## Charlotte Historic District Commission Application for a Certificate of Appropriateness

ADDRESS OF PROPERTY	516/520 Grandin Road, Wesley Heights Local Historic District HDC 2011-026
SUMMARY OF REQUEST	Window Replacement
OWNER	Bobby Drakeford
APPLICANT	Bobby Drakeford

# EXISTING

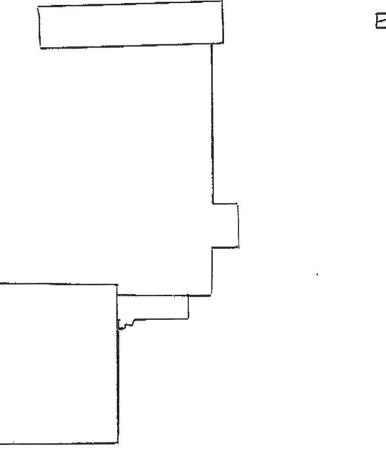
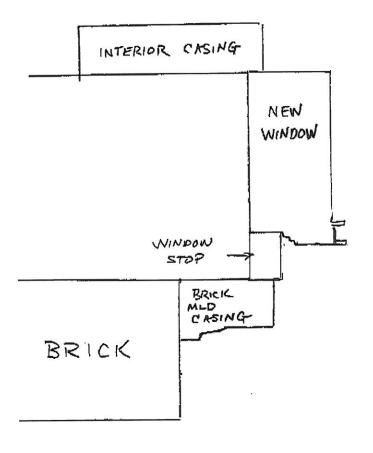
After looking at a sample replacement unit at the March 2011 HDC meeting, the Commission voted to defer a decision on this application until the April hearing, in order to clear up questions that were raised regarding how the units would be trimmed on the exterior once the new units were installed.

The applicant has provided the attached drawings to answer this concern.
